Potential Steering Hardline Contact with Engine Oil Cooler

Product: Groundsmaster® 4300

April 19, 2017

Figure 1

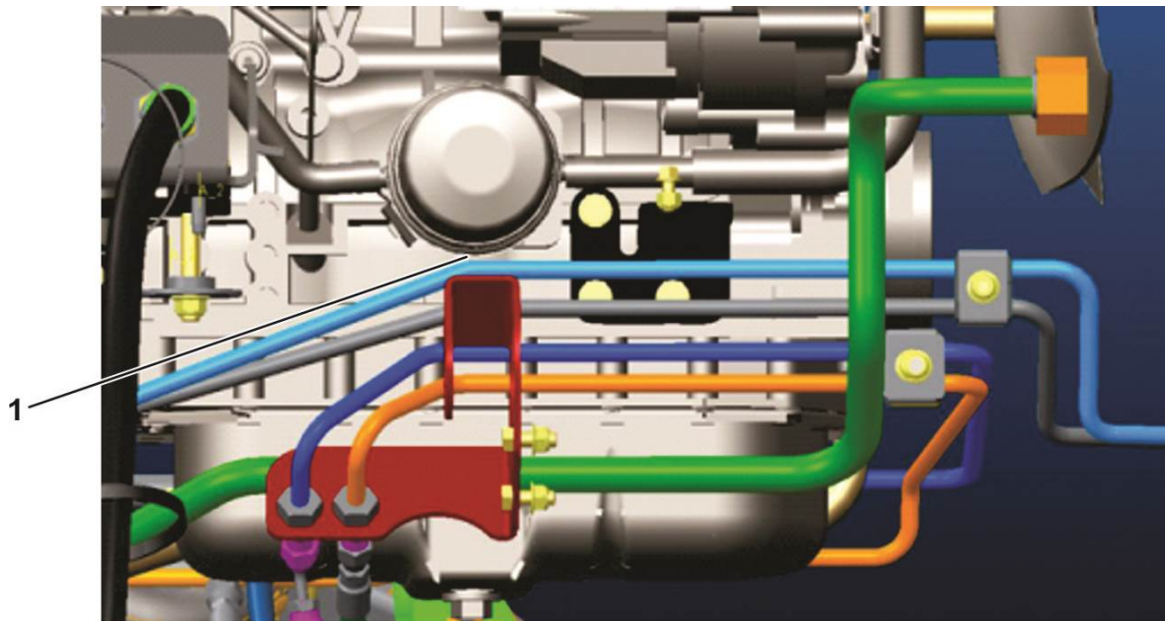
A steering hard line could contact the bottom of the engine oil cooler. If this contact continues, the steering hard line will wear and may ultimately fail.

Area to check for adequate clearance ($\frac{1}{4}$ " or 6 mm) between hard line and

During maintenance, inspect the area near the engine oil filter/cooler to ensure there is ample clearance between the cooler and the steering hard line. If the hard line is contacting the engine oil cooler, bend the line down, away from the cooler until it clears. Inspect the hard line for any damage that could result in failure.
